# DERBY HALL CHURCH

## Section 96A (NMA Statement)

PROJECT NO: AI-2456

STATUS: SECTION 96A PLANNING SUBMISSION

## SOUTH Elevation

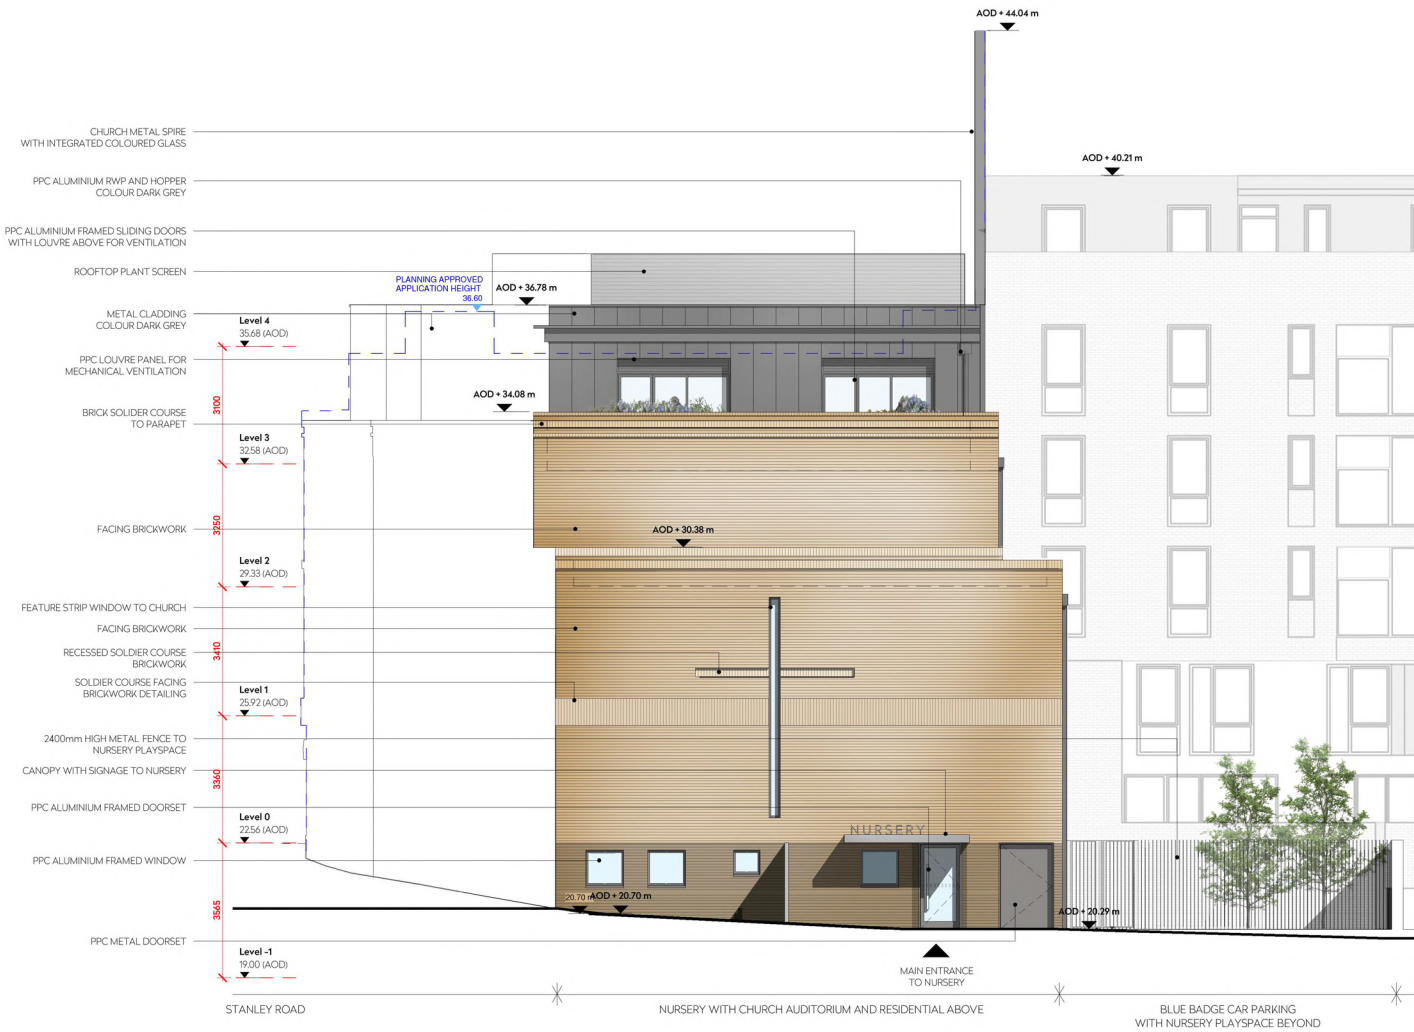
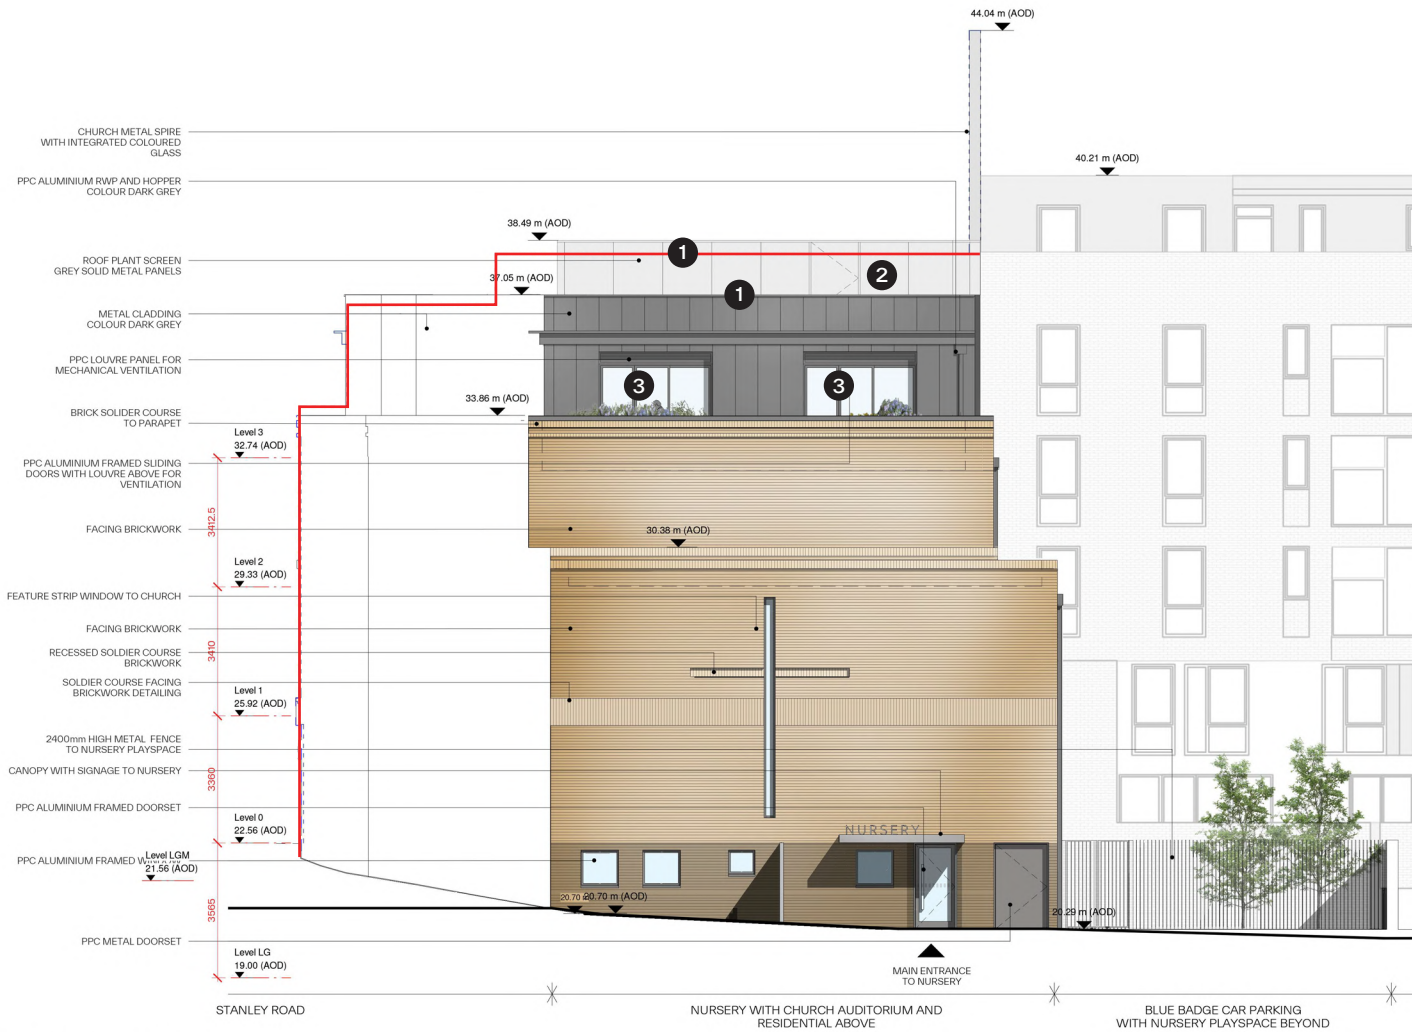
- 1 Parapet levels and plantroom screen slightly raised following detailed coordination with structure and MEP.
  - 2 Roof plant sized adjusted and moved away from residential windows of neighbouring properties to comply with planning noise level. Solid and louvered panels required on roof plant screen to comply with acoustic and ventilation requirements
  - 3 Minor modification of window position
- Line showing approved massing for comparison (approximate)

APPROVED / PROPOSED ELEVATIONS  
EAST Elevation

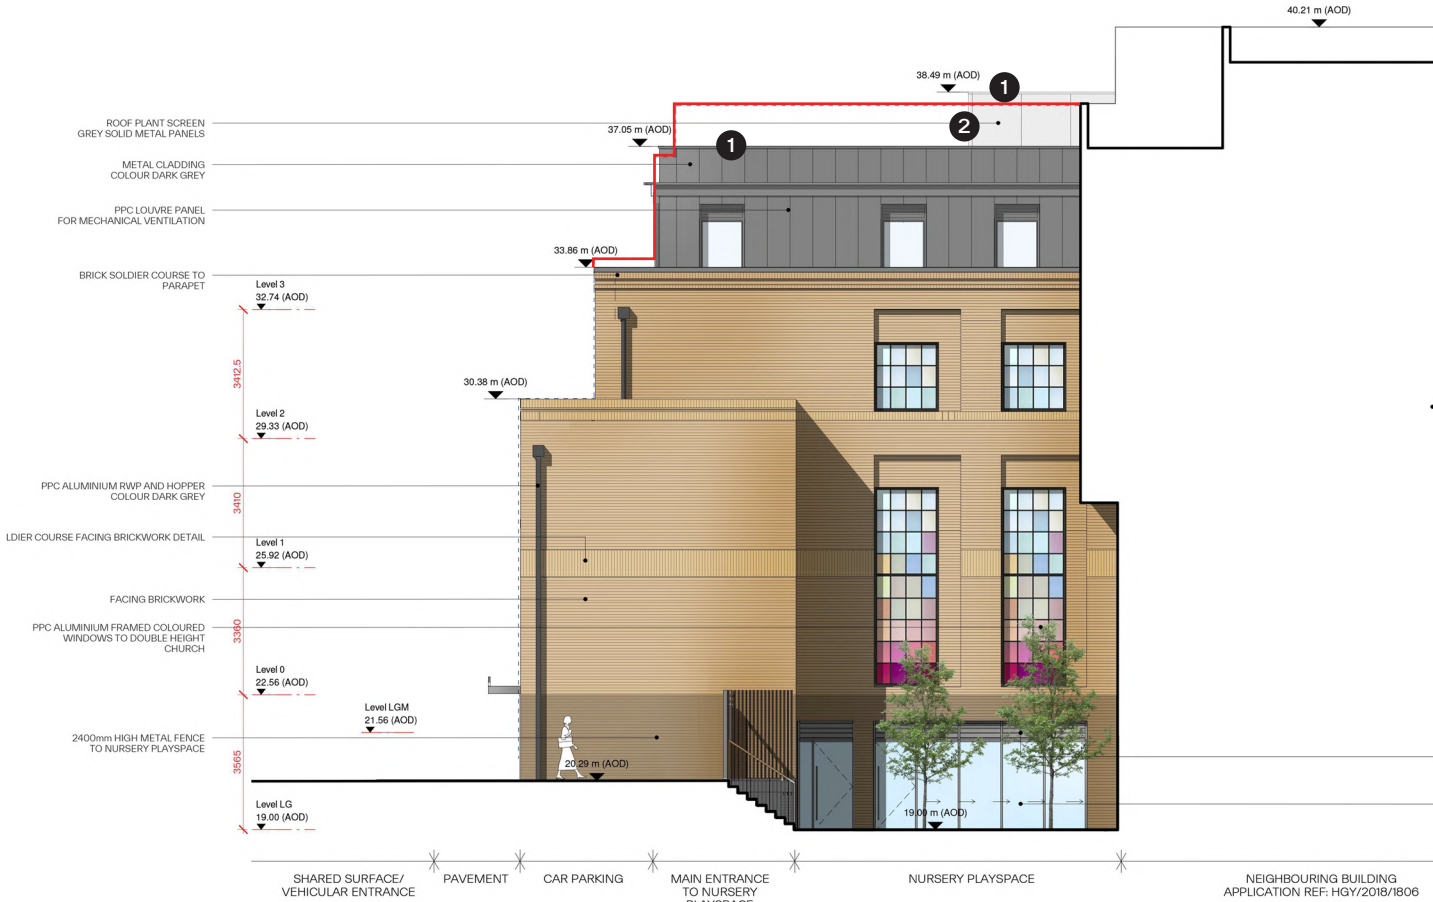
- 1 Parapet levels and plantroom screen slightly raised following detailed coordination with structure and MEP.
  - 2 Roof plant sized adjusted and moved away from residential windows of neighbouring properties to comply with planning noise level. Solid and louvered panels required on roof plant screen to comply with acoustic and ventilation requirements
- Line showing approved massing for comparison (approximate)

# PROPOSED STREET SCAPE VIEW

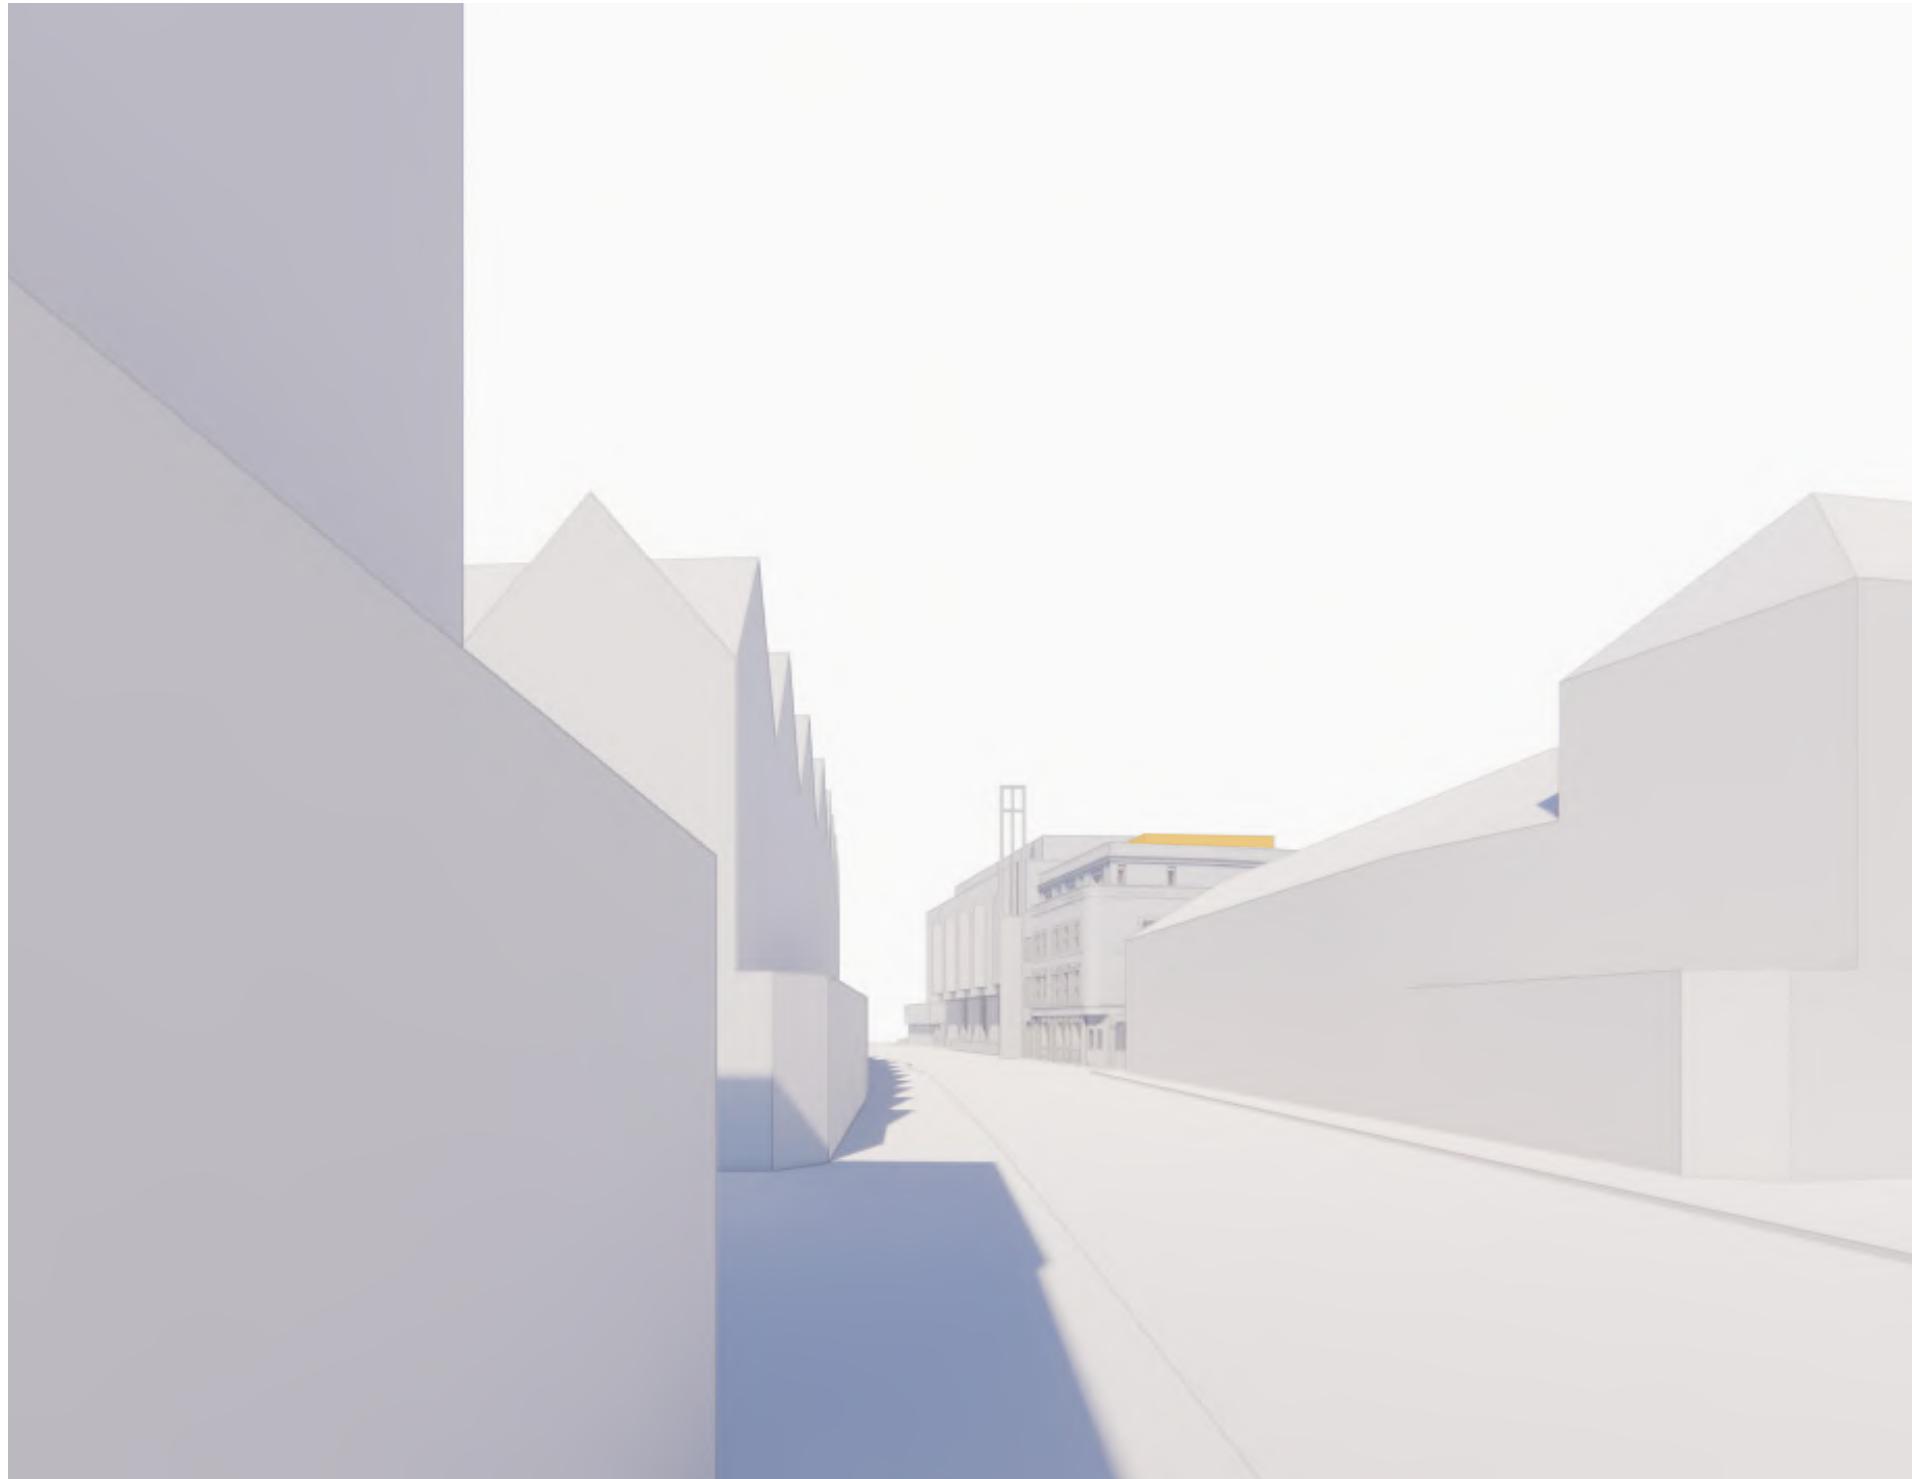
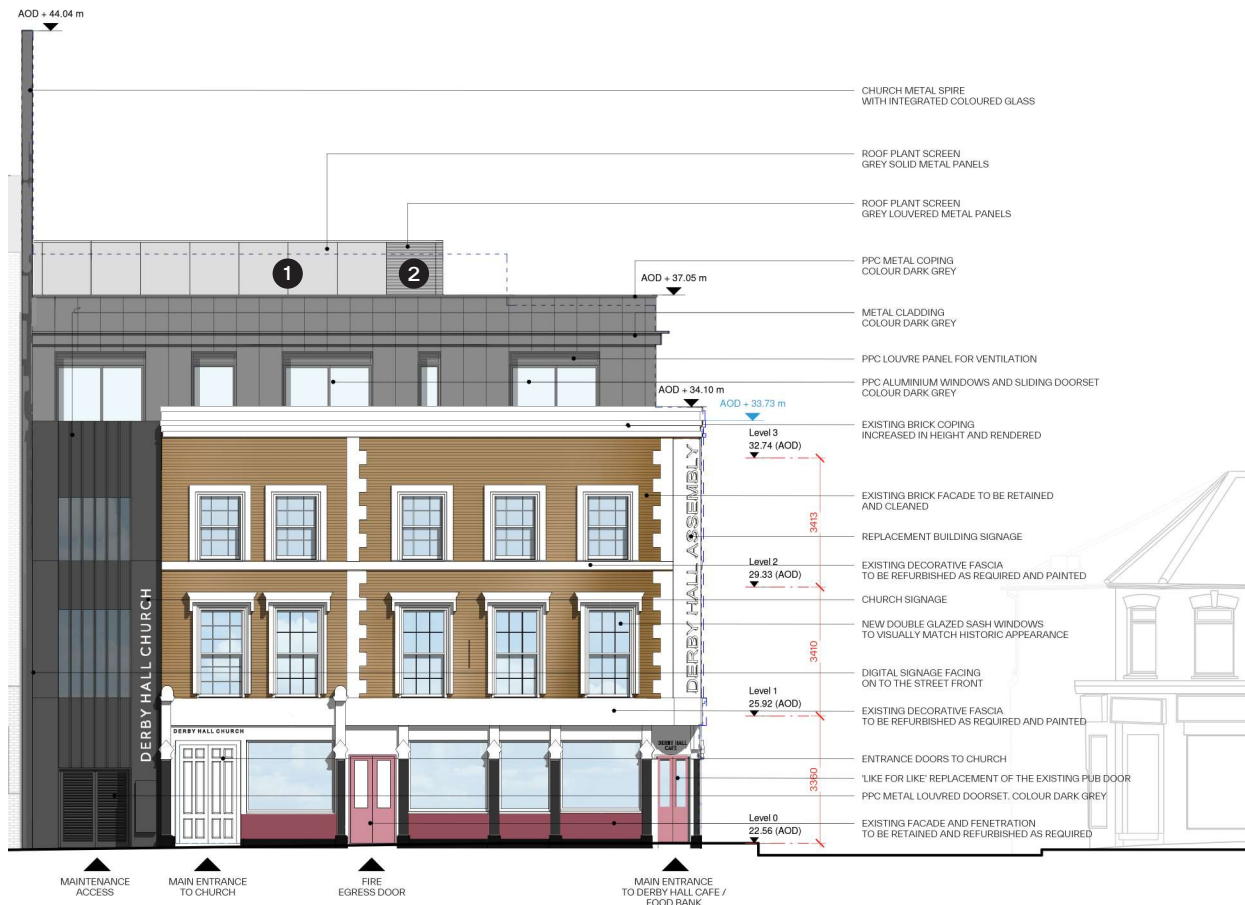
The aim of this visualization is to show the impact of the proposed changes on the long distant view from West Green Lanes, which we believe it's minimal. The height of the roof plant enclosure has been reduced as much as possible as requested during the PreApp meeting with the Council.

From other points of view previously considered, the change has no impact on the visibility of the plantroom.
